Service Tip

Problem: Poor response of AV Receiver to remote commands.

Solution: Change HTR-1 IR transmission frequency.

Diagram 1

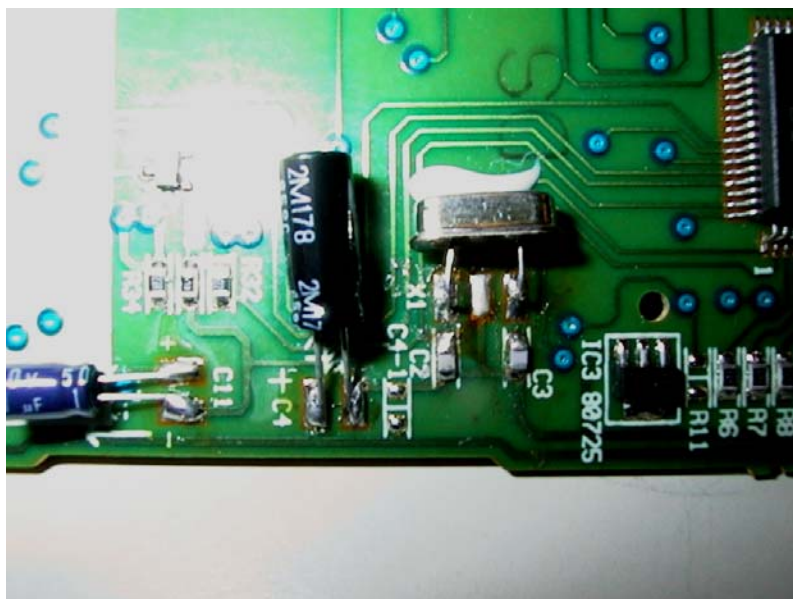
1. Open the case of the HTR-1 by using only a thin but strong plastic screwdriver or similar tool (metallic tool will damage case). There are 5 tabs on each side of the remote that hold it together. Start at the top of the remote on either the right or left side. Locate the slot that runs along the side of the remote. By inserting and pressing the screwdriver down on an angle towards the bottom part of the case the tab should release. Work your way down the remote releasing the tabs and the case will open up. See Diagram 1 for reference.
